Bulletin: # **SR - 5H - 005**  
Release Date: **May 22, 2000**  
Effective Date: **May 22, 2000**  
Supercedes: **N/A**  
Completion Date: **August 1, 2000**

# SAFETY ALERT

<b>Ride Manufacturer:</b>	Man-Co Mfg., Inc. Dartron Industries, Inc.	<b>Affected Production Dates</b>	1988 through 1999
<b>Ride Name:</b>	Hurricane	<b>Affected Serial #'s:</b>	All
<b>Model Number:</b>	All

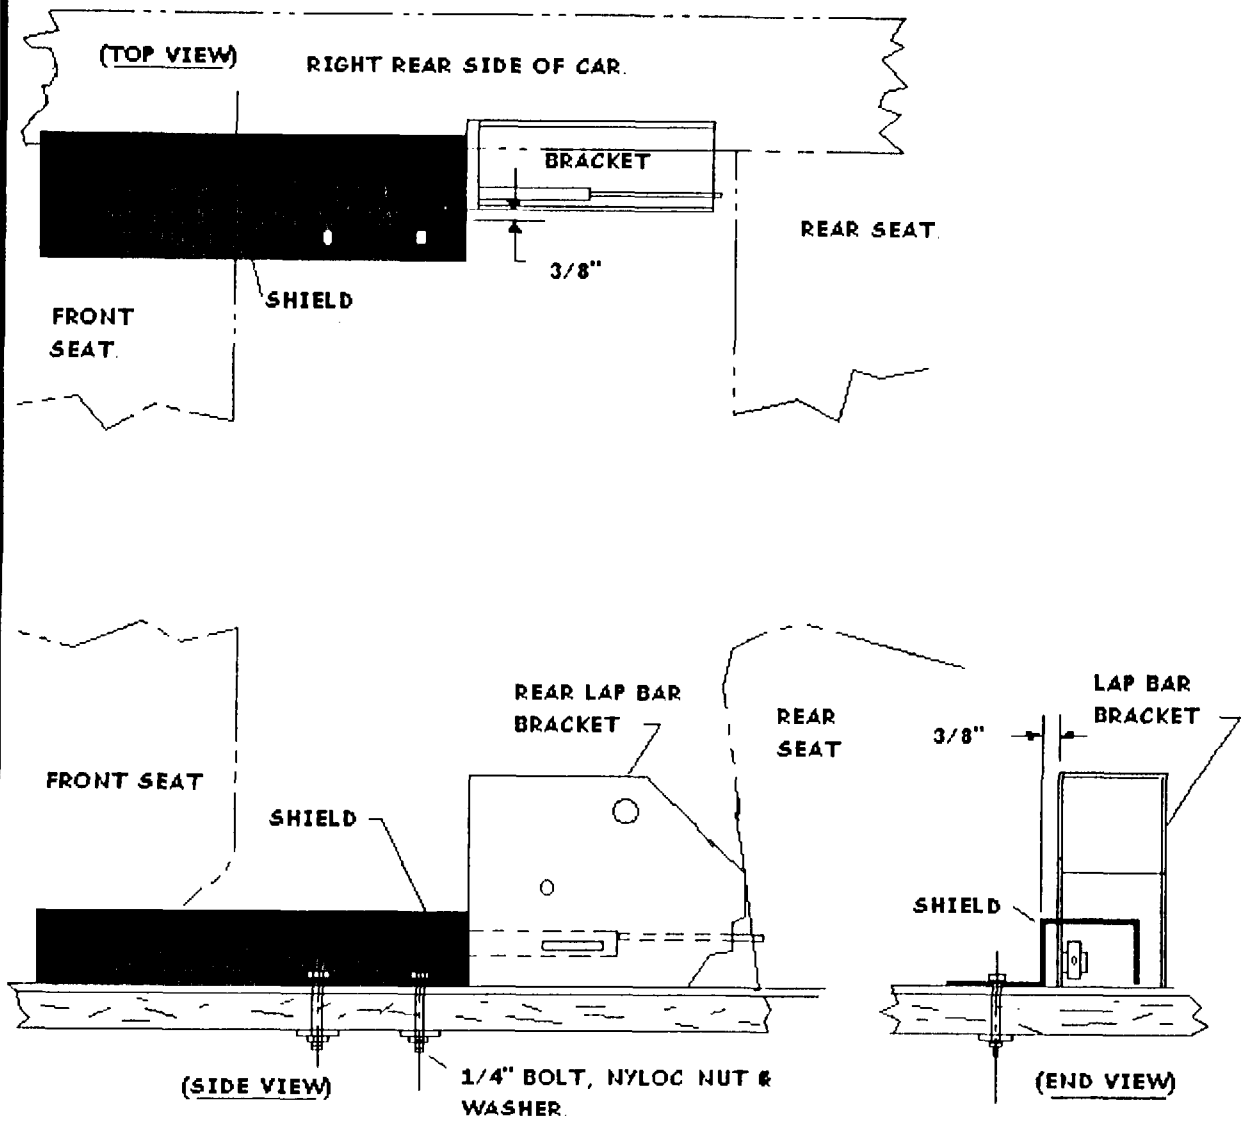
**Reason For Release:** It may be possible for a passenger in the back seat to release one or both passenger restraints by using a foot to maneuver the restraint release linkage rod.

A shield provided by Dartron should be bolted to the car floor in such a manner that the rod is shielded from the hands and feet of passengers in the back seat of the car.

**Action to be Taken:** A shield manufactured by Dartron MUST BE installed over the rear seat restraint release linkage rod by owners of Hurricane rides manufactured by Man-Co and Dartron.

Using the holes in the shield flange as templates, drill 2 holes 17/64" dia. through the floor of the car. Install bolts, washers, and locking nuts as shown below.. Tighten bolts to no more than 100 in lbs of torque. CAUTION: Do not over-tighten nuts. They should be snug and not dimple fiberglass.

POSITION THE SHIELD SO THAT IT IS AGAINST THE REAR LAP BAR BRACKET AND 3/8" OUT FROM THE FACE OF THE BRACKET (AS SHOWN ABOVE)
